Access Compliance Report

Public Rights-of-Way

Intersection ID: N/A	Main Street:	Cross Street: N/A	Location: N/A
ADA ID: 05B42E150976	Signal Type: One Push Button-APS	Overall Compliance: No	Severity Score: BTN 1: N/A BTN 2: N/A No BTN: N/A
Codes/Mitigation Info/Possible Solution		Field Measurements/Component Compliance

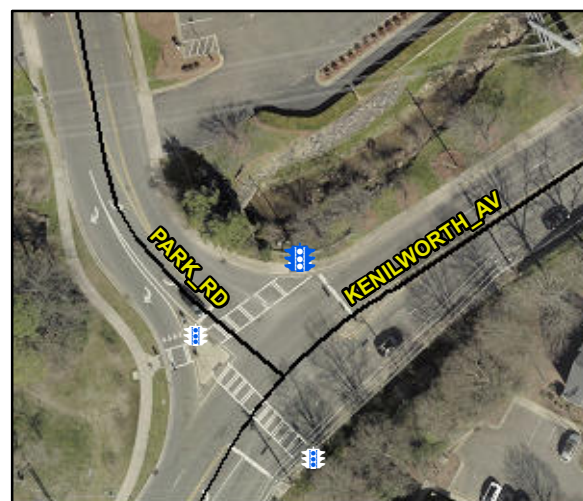
Possible Solutions: Remove & Replace
Replace APS Button With New APS Button.
Remove and Replace Clear Space.

PROW/ADA: R410.6, R404.2, R404.3, R406.2,
R209.1, MUTCD 4e.10
